**Item No. 7.1.2**  
**Design Review Committee**  
**March 12, 2015**

**SUBJECT:** **Case 19725, Substantive Site Plan Approval, Mixed-use Development, 5161-5175 South Street, Halifax**

Attachment A - Site Plan Approval Plans

## 4.3.4. HEIGHT TRANSITION

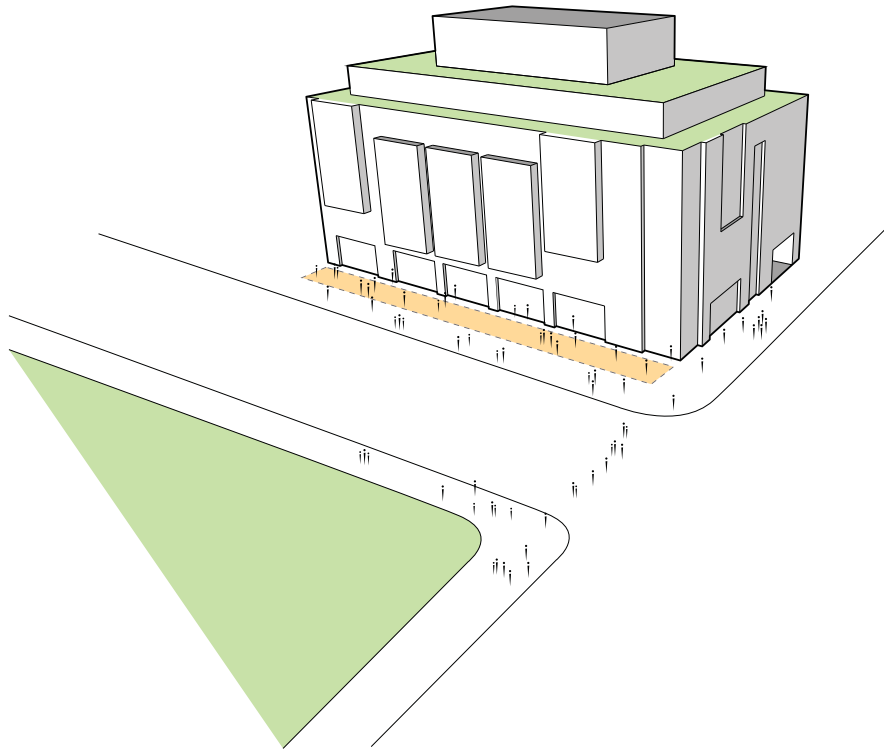
Sections 4.3.4a and 4.3.4b require a 45 degree angular plane setback relative to an adjoining heritage building. The project's architect addresses this within the Design Rationale on page 13 (Attachment B). Only the very top corner of the proposed building does not meet the angular plane requirement from the upper edge of the Honourable William Annand House. Under the Heritage Guidelines, this portion of the building would need to be stepped back a minimum of 3 metres from the face of the building. This does not appear to be warranted given the relatively minor scale of the portion of the building that exceeds the guideline.

# Attachment C - Requested Variances

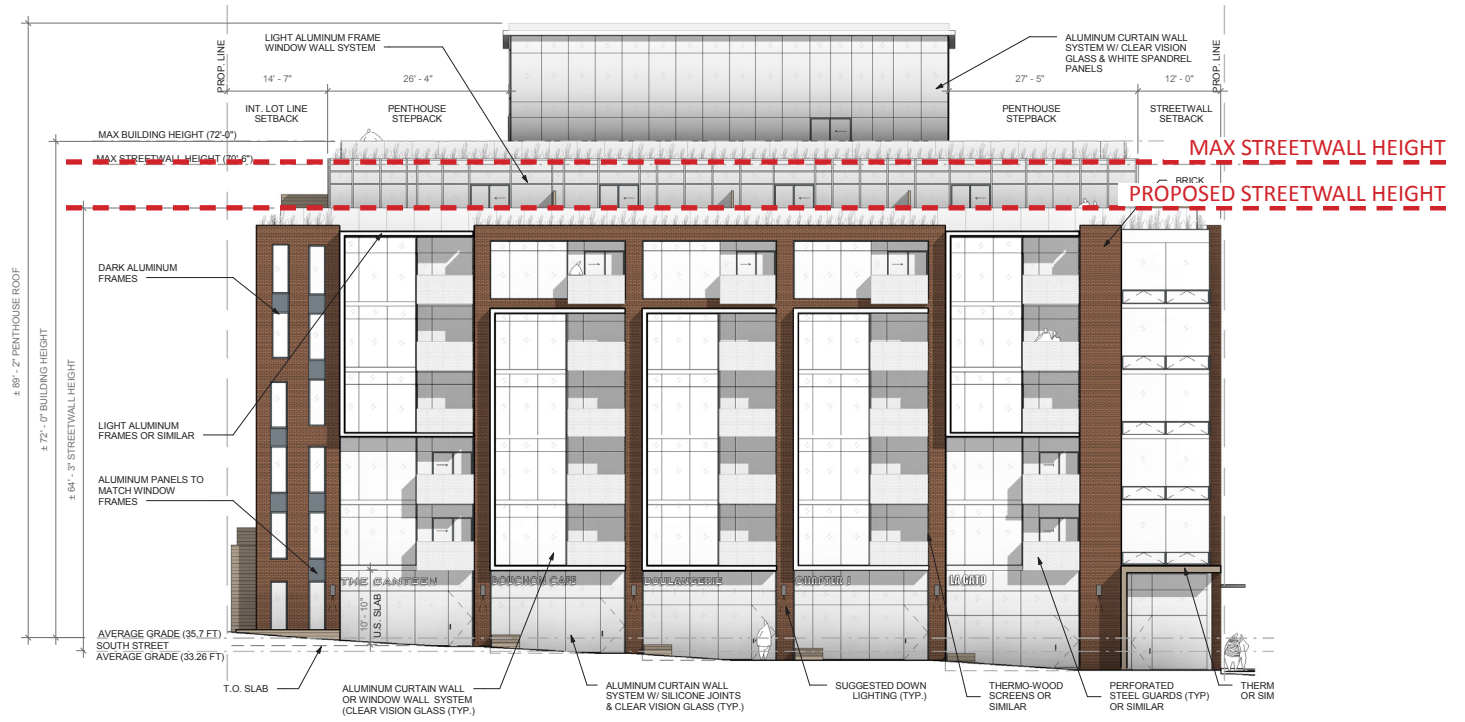
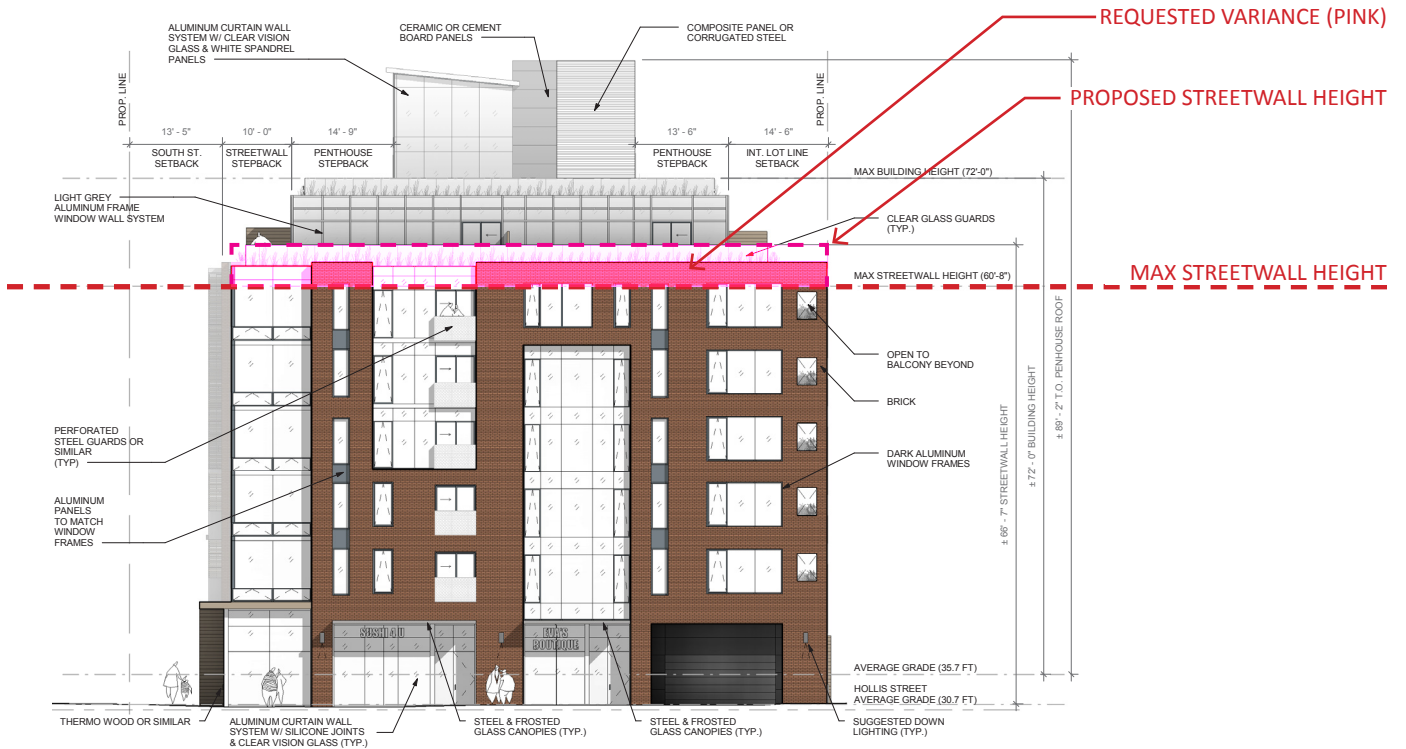
- 1) Streetwall Height: Section 9, Subsection (2). Maximum streetwall heights are to be in accordance with Map 7 of the By-law, which establishes a Maximum Streetwall Height of 18.5 metres on Hollis Street.

*Non-compliance:* Approximately 1.8 metres of the streetwall, which includes the roof enclosure (guardrail) and upper portion of the building face, exceeds the maximum streetwall requirement.

*Response:* The proposed street wall is not substantially taller than the requirement in the Land Use By-law. Parts of Design Manual, including section 3.1.3, call for a 1:1 streetwall height to right-of-way relationship. The Hollis Street right-of-way width in this area ranges from approximately 19.2 to 20.6 metres, which is consistent with the height of the streetwall that is proposed with the new building. With regard to the variance conditions, the proposed streetwall height does serve to join the South Street streetwall. In addition, with specific regard to 3.6.3c, while the proposed streetwall is taller than the streetwall of the Honourable William Annand House, it is consistent with streetwall character of the street that is partly defined by the 8 storey Terminal Road Office Building and the 11 storey Westin Hotel.
